Subject: **Response to Portion of NRC Request for Additional Information Letter No. 103 Related to ESBWR Design Certification Application - Heating, Ventilation, and Air Conditioning - RAI Number 9.4-42**

**Response to Portion of NRC Request for  
Additional Information Letter No. 103  
Related to ESBWR Design Certification Application  
Heating, Ventilation, and Air Conditioning  
RAI Number 9.4-42**

**NRC RAI 9.4-42**

Figure 9.4-9 CLAVS Simplified System Diagram

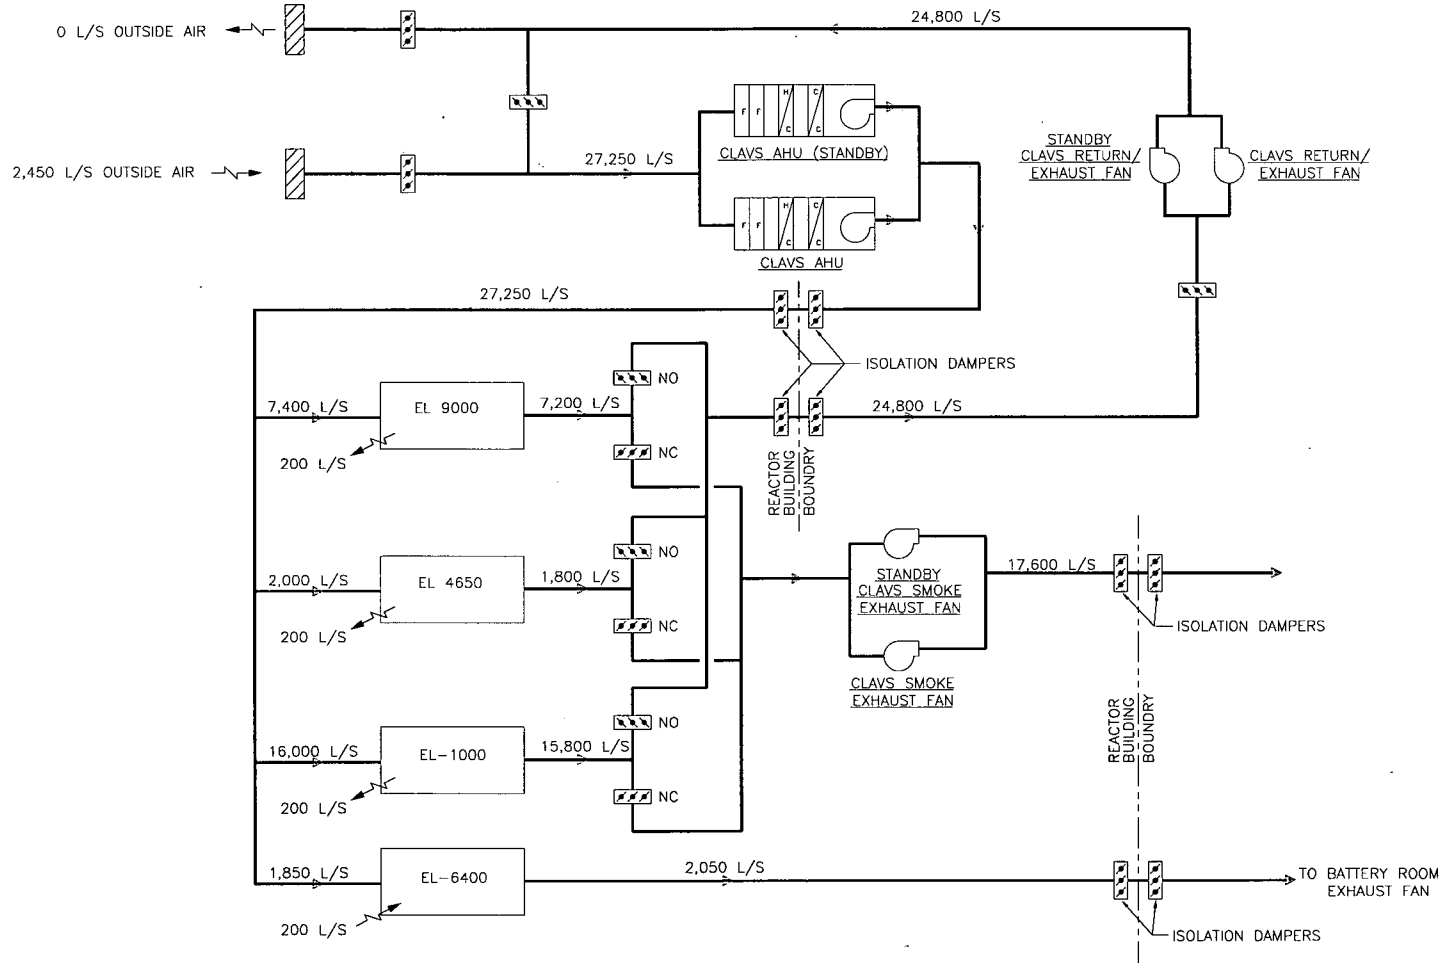
*DCD, Tier 2, Revision 3, Table 9.4-9 does not list safety-related isolation dampers. Please add this item to the table with appropriate information. Figure 9.4-9 has a variety of dampers. Please identify the isolation dampers that are safety-related and coordinate with Table 9.4-9.*

Table 9.4-9 corresponds to the Clean Area HVAC Subsystem that serves the clean (non-radiologically controlled) areas of the Reactor Building. This clean area has Safety-related isolation dampers at the RB wall. Figure 9.4-9 and Table 9.4-9 will be updated to include these dampers.

DCD Tier 2 Figure 9.4-9 and Table 9.4-9 will be revised in the Revision 5, to include the building isolation dampers, as indicated on the attached mark-ups.
